**PROPOSAL FOR AMENDMENT TO ECE/TRANS/WP.29/2007/106**

**A. PROPOSAL** (Provisions for vehicle stability control systems)

**The comparison of accident cause between Germany and Japan for vehicles of the classes N2, N3, and M3**

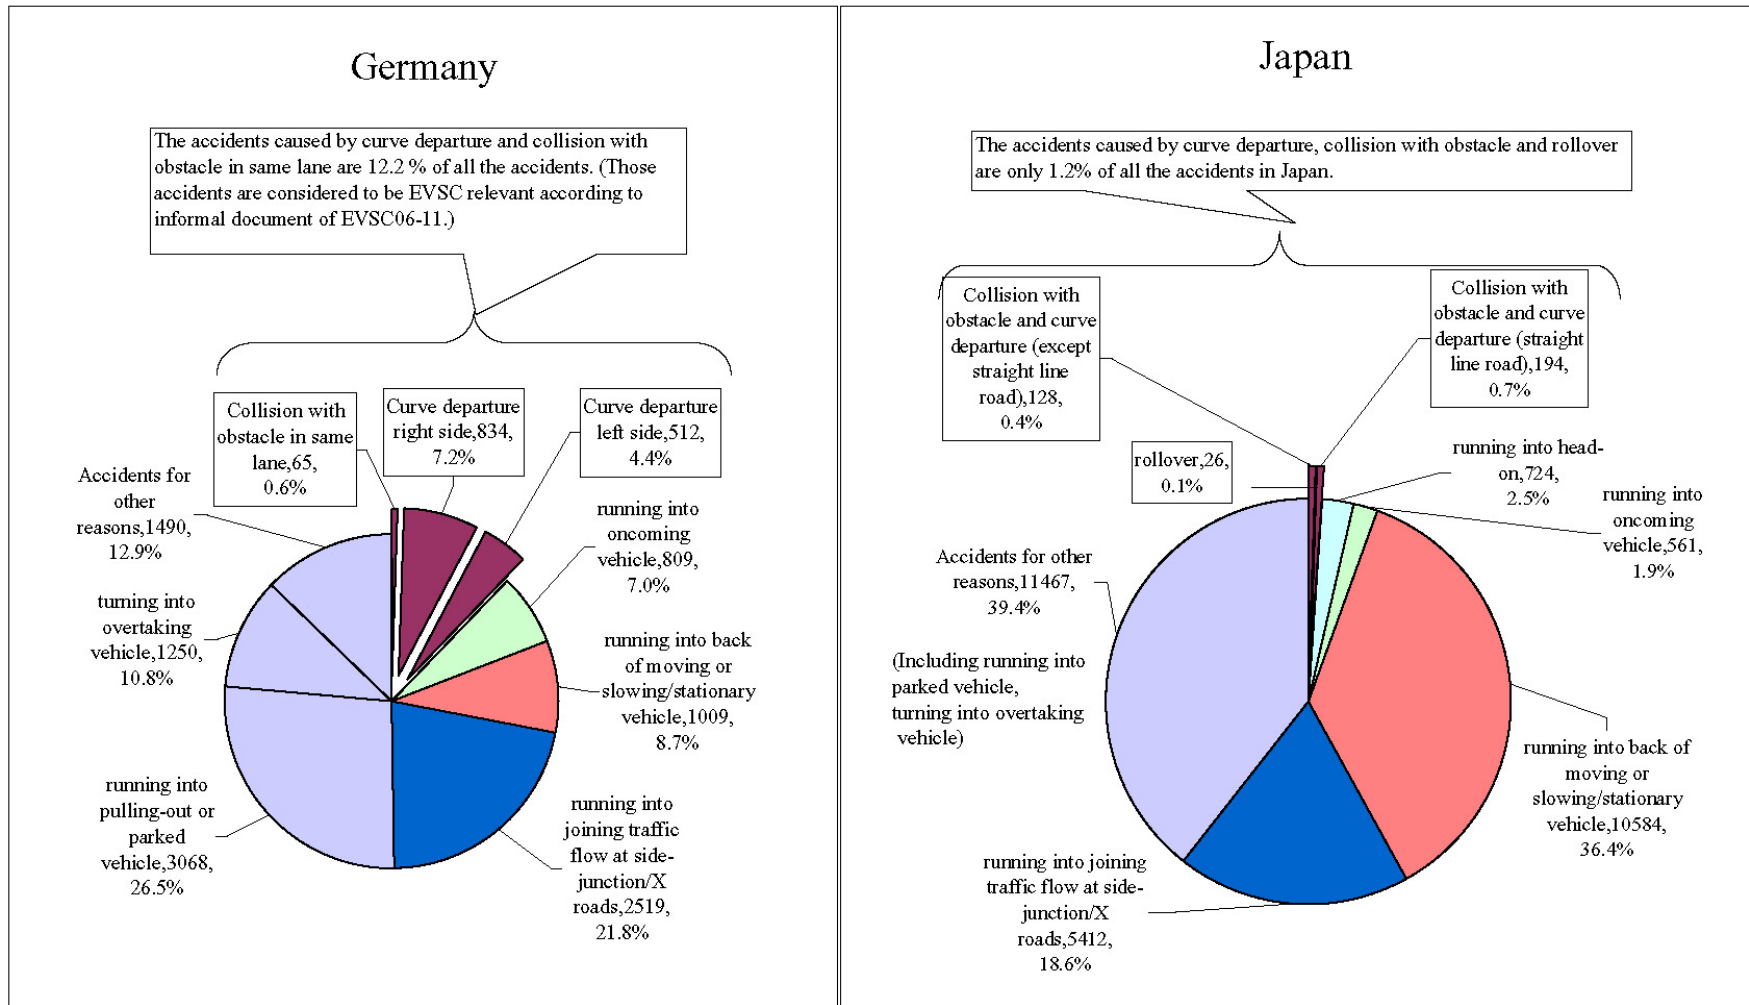
Japan is not favorable to mandate EVSC installation for vehicles except M1/N1 categories. It is too early to mandate such a wide category at one time, because testing method is not still mature and the patterns of accidents are different between Europe and Japan. (Analysis result of accidents in Germany and Japan is attached for reference.). ADR vehicles and long distance touring busses and coaches categories are considered for mandatory at first. And we think it appropriate for the first step. But we also understand the European situation that EVSC installation is very important and urgent matter. Therefore we propose the compromise proposal considering upper situations. Our proposal makes it possible not to mandate EVSC installation on the basis of national regulations. But considering the formal proposal has been already submitted from EC to WP.29, we added the footnote in our proposal to minimize modification.
